DATE: 11/9/2007

**SUBJECT: FINDING OF NO SIGNIFICANT IMPACT (FONSI) FOR AGRICULTURE  
BIOMASS-TO-ENERGY FACILITY, KŌLOA, KAUA'I, HAWAII  
TAX MAP KEY (4) 2-7-001-001**

Figure 2-3  
Proposed Pipeline Alignment  
Agriculture Biomass-to-Energy Facility, Kōloa, Kauaʻi  
Environmental Assessment

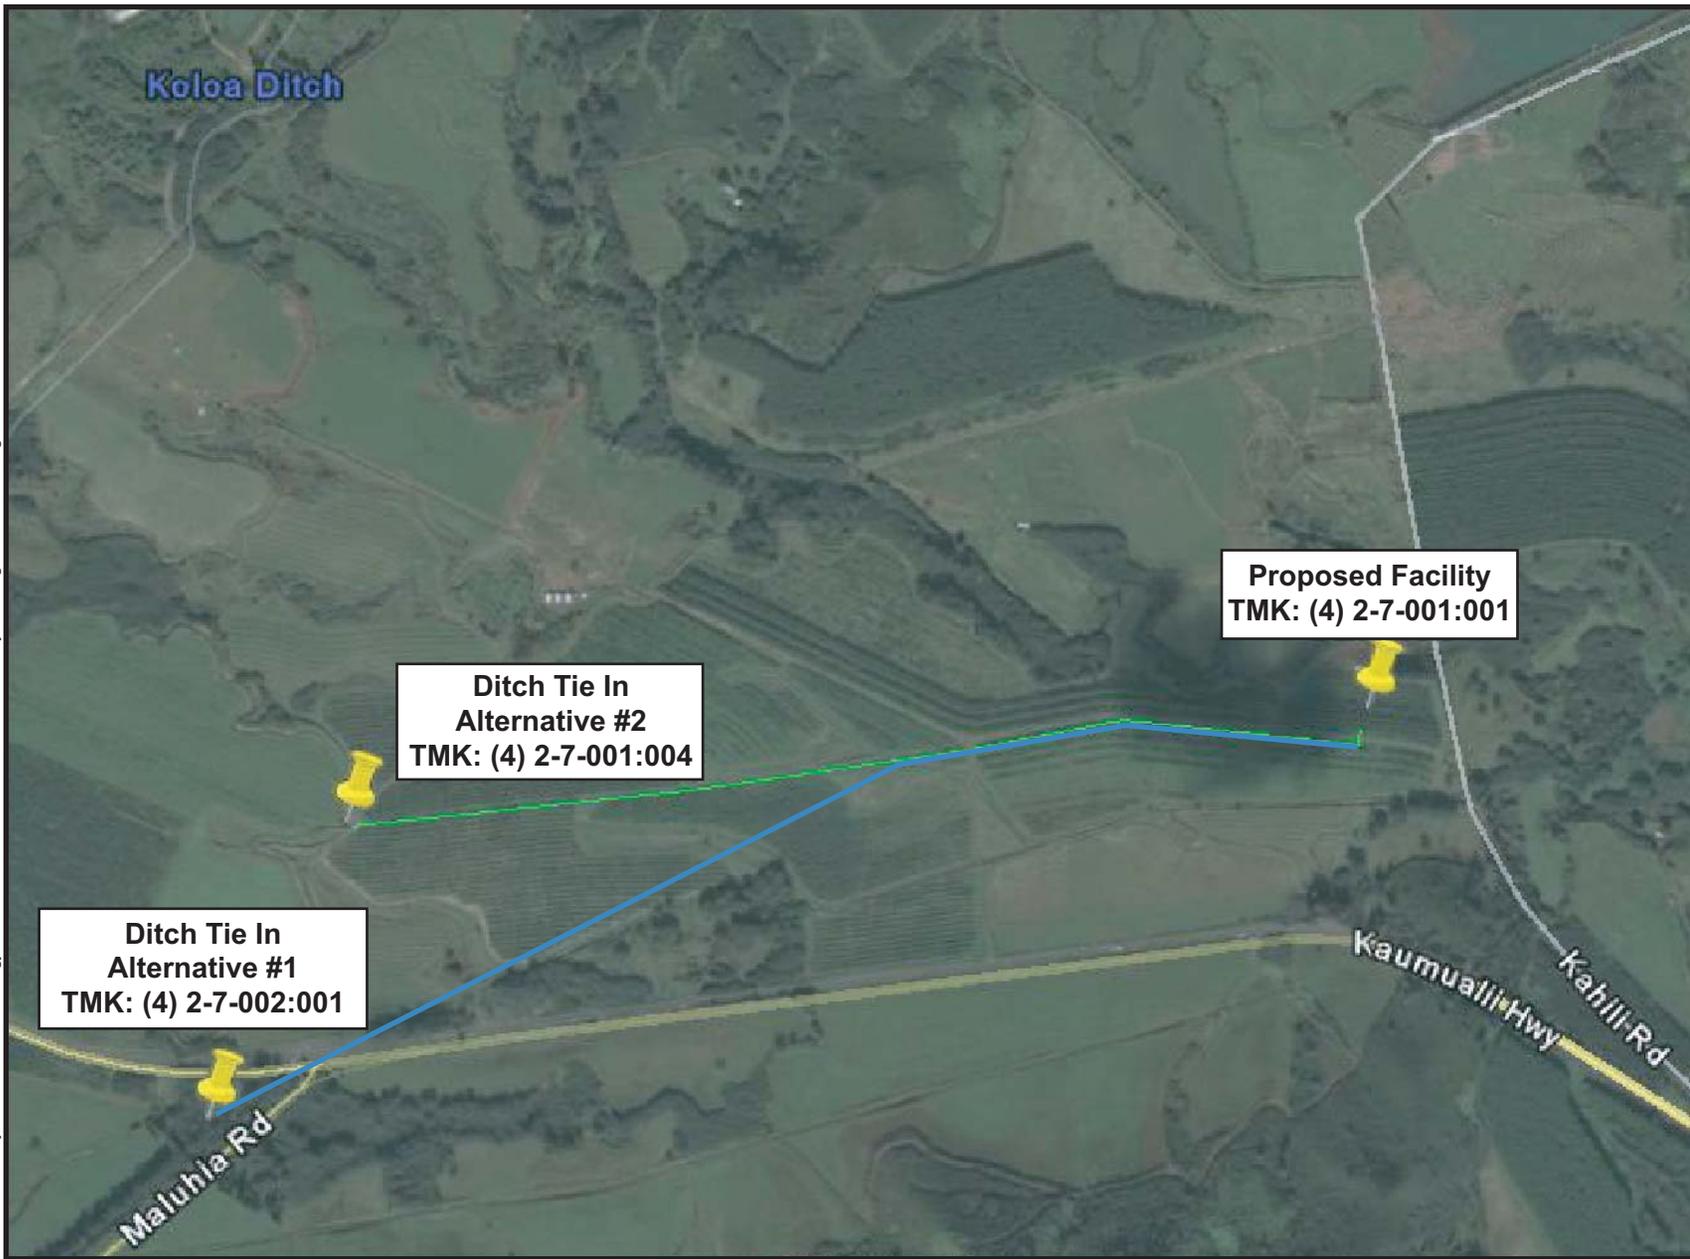
Response: The correct wording is "would be treated prior to being released"; correction made.	
5	On page 4-11, please describe/identify the discharge point of effluent back into the Kōloa Ditch System. The water intake process or tie-ins are discussed in detail and shown on Figure 2-3. Will the tie-in points also serve as discharge points? Please describe this process.
